Orwell Park (Templeogue) Residents Association
c/o 23 Orwell Park Rise
Templeogue
Dublin 6w

January 2022

**Observations by Orwell Park (Templeogue) Residents Association (OPTRA)
on the Wellington Lane Walking and Cycling Scheme**

Figure 2.1 From Luas to Ground level

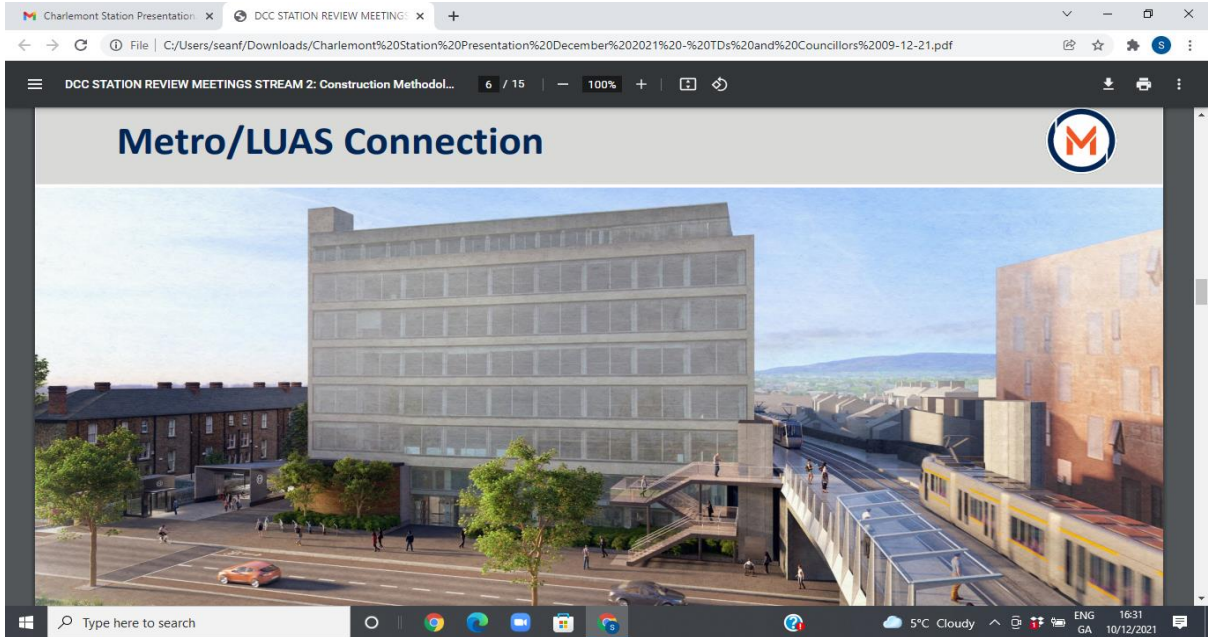
As the drawing shows, passengers would descend three flights of steps to reach ground level.

Figure 2.2 From Ground level to Metro

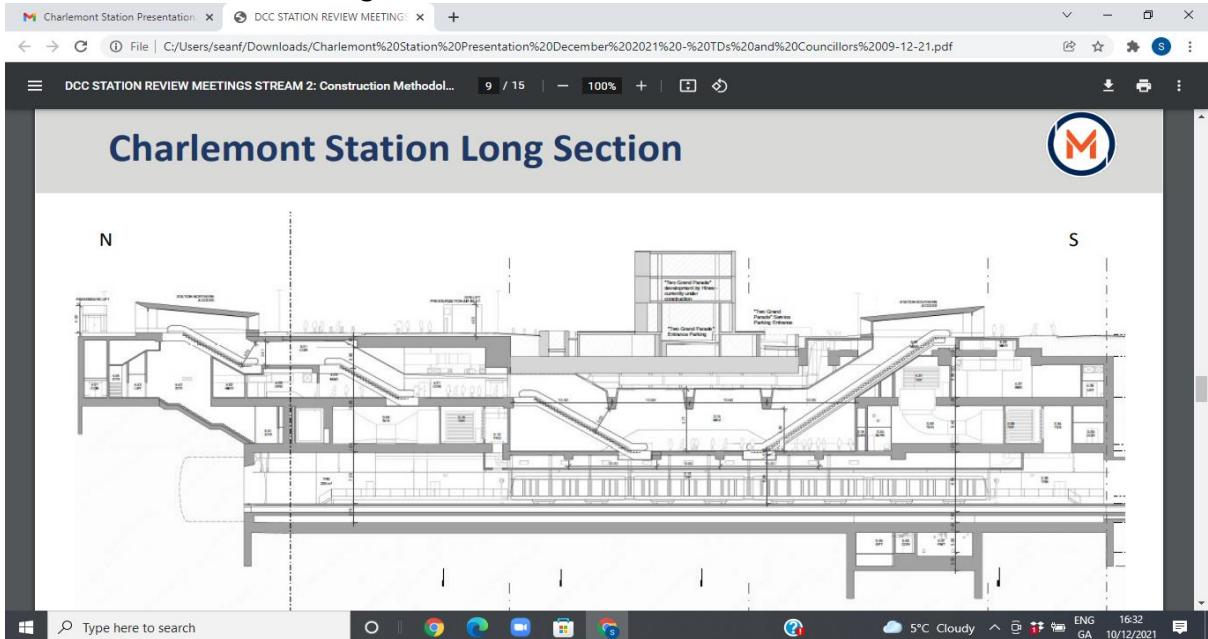
On entering the metro station (shown at the top left of the drawing) passengers would have to descend three escalators to reach the trains.

Thus, for passengers to switch from one mode to the other, they would have to traverse three flights of steps and three escalators. How could this improve the passenger experience, including for those who have difficulties moving about? Indeed, many incoming Luas passengers might forego transferring at Charlemont; they might rather stay on the Green Line and transfer to *MetroLink* at St Stephens Green.

2.8 The right hand side of Figure 2.2 above shows that passengers could access the metro quite easily from street level on the southern side of the proposed metro station. On entering the station, one escalator would bring the passengers to the trains. **If the interchange was located at St Stephens Green, such easy access could be made available to all passengers wishing to transfer from Luas to metro and vice versa.**

Figure 5.1 Alignment A

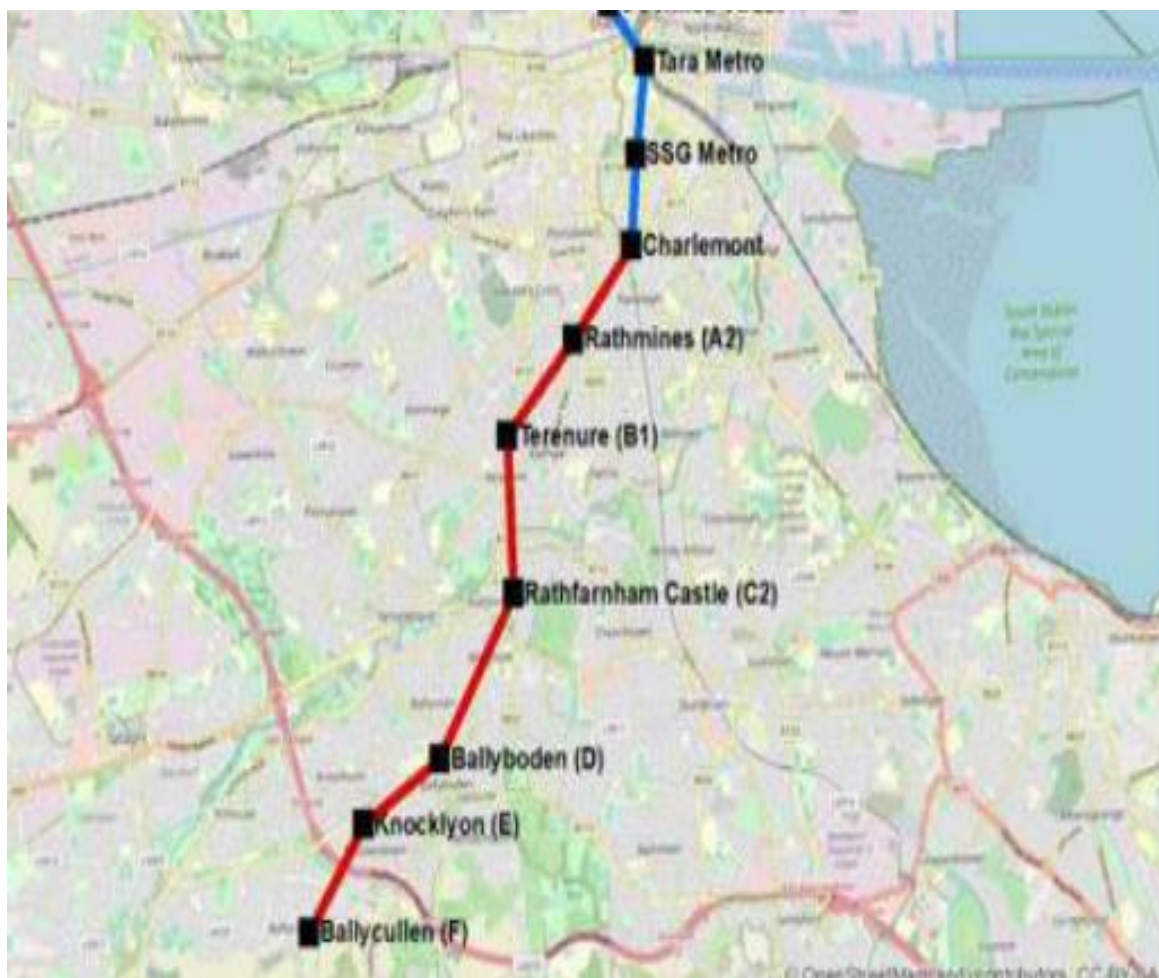
If the interchange of *MetroLink* with the Luas line was in St. Stephen's Green, rather than Charlemont, the continuation of *MetroLink* to South-West Dublin could be achieved at a much lower cost. A better, less constrained, route-alignment could then be facilitated to serve South-West Dublin.

5.6 The *Feasibility Study* confirms that the continuation of *MetroLink* to South West Dublin is technically feasible. Here are some metrics from the *Feasibility Study*:
